Re: State of Utah Division of Radiation Control ("DRC") Request for Information Letter of January 12, 2011 Regarding Reclamation Plan Revision 3.2A, Utah Radioactive Materials License UT1900479

This letter transmits Denison Mines (USA) Corp's proposed addendum, entitled Revision 3.2 Edition B to the approved Reclamation Plan Revision 3.0 and submittals referred to as Revision 3.1 for White Mesa Mill ("Revision 3.0/3.1"). This letter also responds to DRC's Request for information ("RFI") letter of January 12, 2011 requesting additional changes to previously submitted versions of this document. As requested in the DRC letter, the addendum has been entitled Reclamation Plan Revision 3.2.Edition B ("Revision 3.2.B"). and all changes have been linked to the previously approved version, Revision 3.0/3.1.

**White Mesa Mill Reclamation Plan**  
**Revision 3.2 Edition B (“Revision 3.2.B”)**  
**Addendum/Changed Pages**

**FIGURE A-5.1-3**  
**RECLAMATION COVER AND CROSS SECTIONS**  
**RECLAMATION PLAN REVISION 3.2.B**

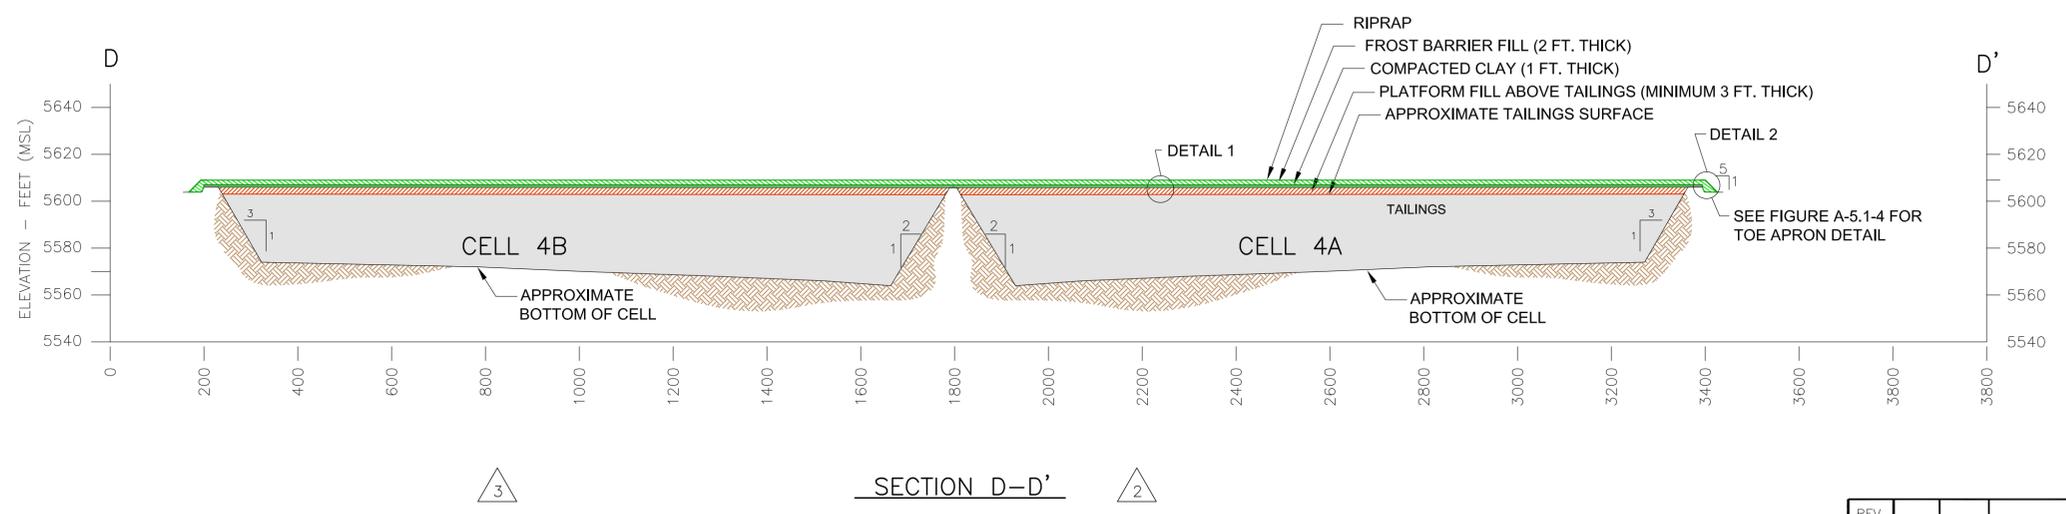
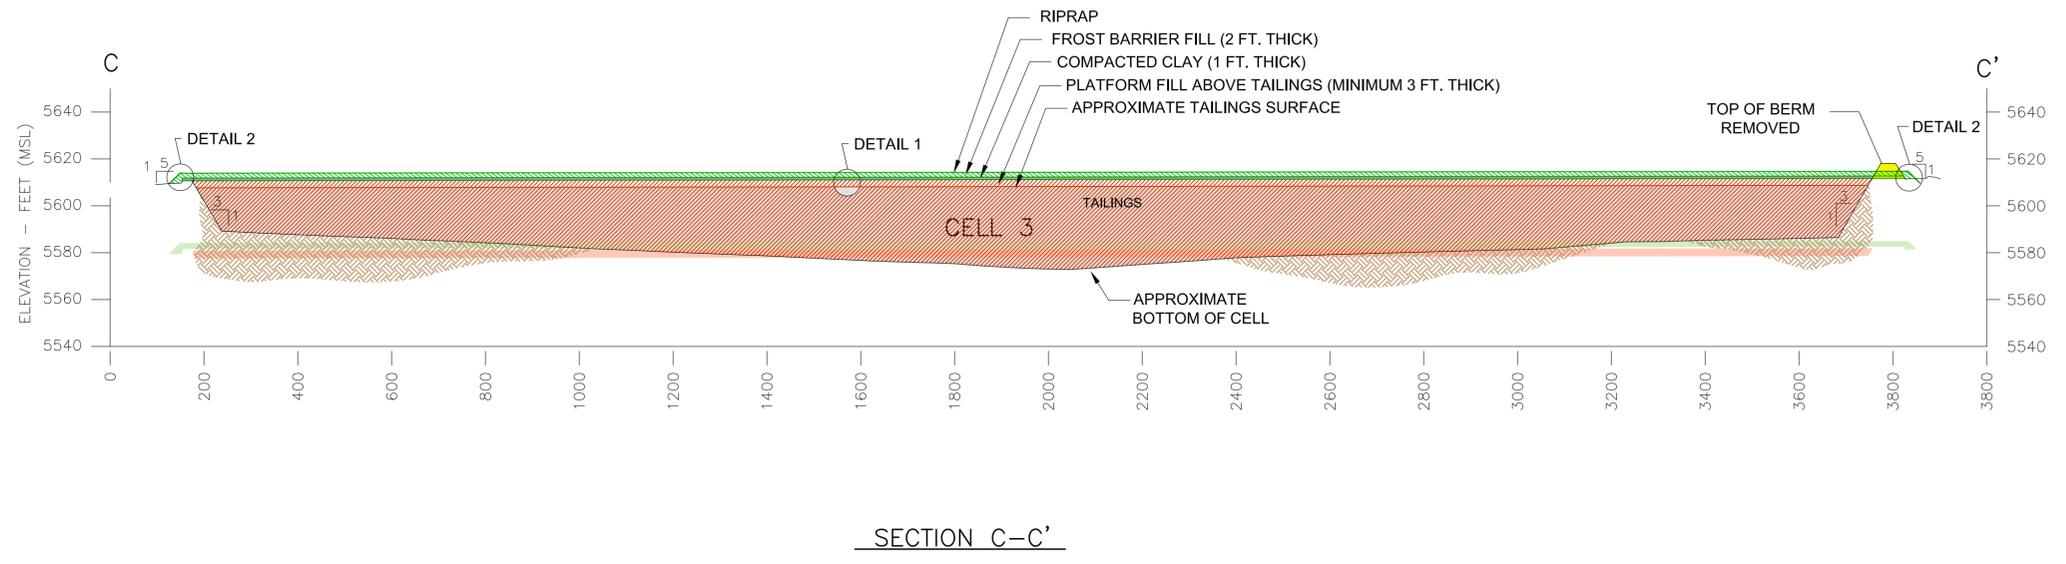
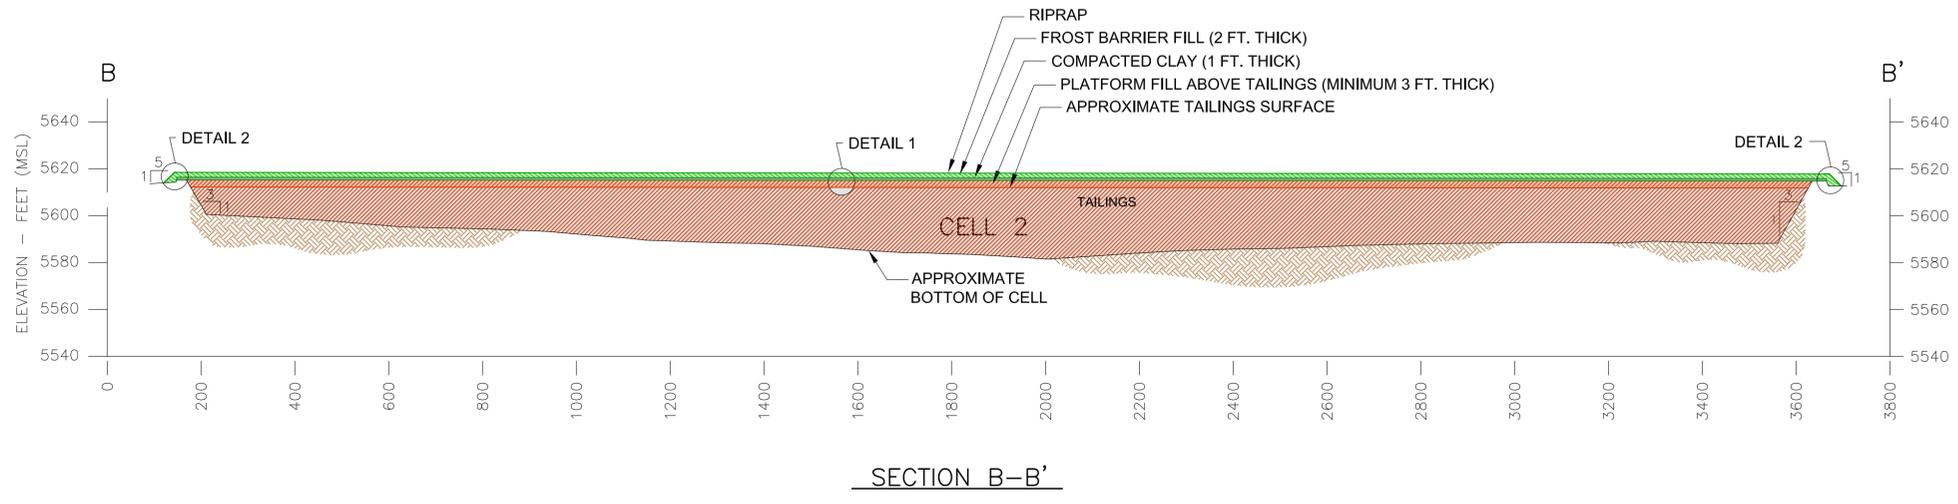
a. Correct a transposition of figure numbers by changing the figure numbers proposed as Figures A-5.1-2 and A-5.1-3 in Rev. 3.2A to correspond to the figures of the same number from Rev. 3.1.

b. Section D-D' needs to be revised to include the addition of Cell 4B.

Denison Response: The transposition of figure numbers has been corrected.

Denison Response: Section D-D' has been revised to include Cell 4B.

REV. No.	DATE	BY	REVISIONS
1	11/19/08	RAH	Delete clay layer from exterior side slopes, change layer names, & change title block.
2	3/11/08	dmf	Add section D-D'
3	2/10/10	DLS	Add detail reference on section D-D'
4	12/17/10	BM	Revision date update
5	01/13/11	BM	Add CELL 4B on section D-D'

FIGURE A-5.1-2  
 RECLAMATION COVER DETAILS & CROSS SECTION  
 RECLAMATION PLAN REVISION 3.2.B

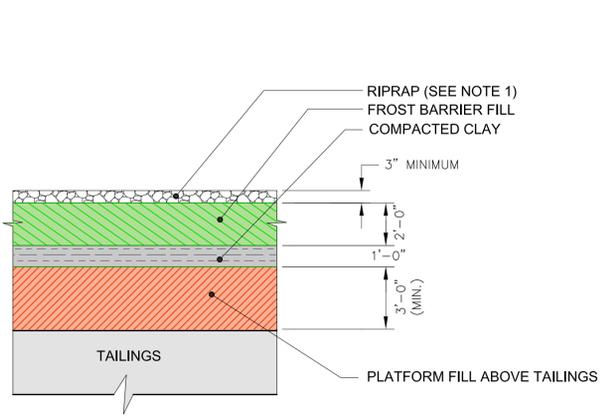
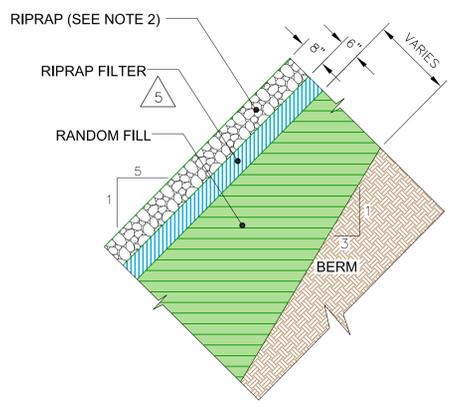
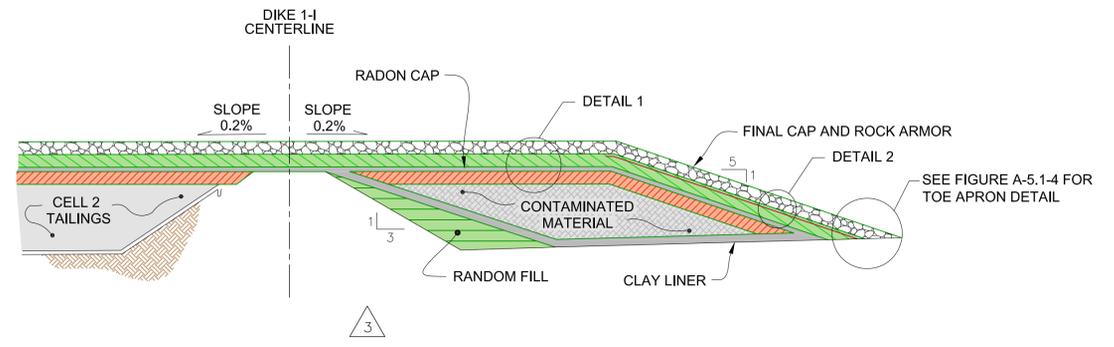
1. Our letter of November 30, 2010, paragraph 3, stated that, "Existing Figure A-S.1-2 in approved Revision 3.1 appears to contain cross Sections and details which are essential to be retained in the Reclamation Plan."

a. Therefore, existing Figure A-5.1-2 must somehow be retained 'and not replaced by the Addendum..."

The referenced Figure A-5.1-2 in Reclamation Plan Rev. 3.1 (labeled on the figure to include drawings through Rev. No.4 dated July 9, 2008), provides Section A-A' and Details 1 through 3. The figure is titled, "... Reclamation Cover Details. and Cross Section."

In contrast, Reclamation Plan Rev. 3.2 provided a Figure A-51-2 titled, "Reclamation Cover and Cross Sections ... " This figure provided Sections B-B', C-C', and D-D'. Not the same sections or details as Rev. 3.1. As stated in DUSA's letter of June 29, 2010, it appeared that this figure was provided as a "replacements for" the figure of the. same figure number. However, the latter Figure A-5.1-2 (Rev. 3.2) does not contain any of the drawings provided in the earlier Rev. 3.1 figure of the same name. Therefore, to keep the original drawing concepts provided on Figure A-5.1-2 (Rev. 3.1), DRC requested that the, "existing Figure A-5.1-2 must somehow be retained and not replaced by the Addendum ... "
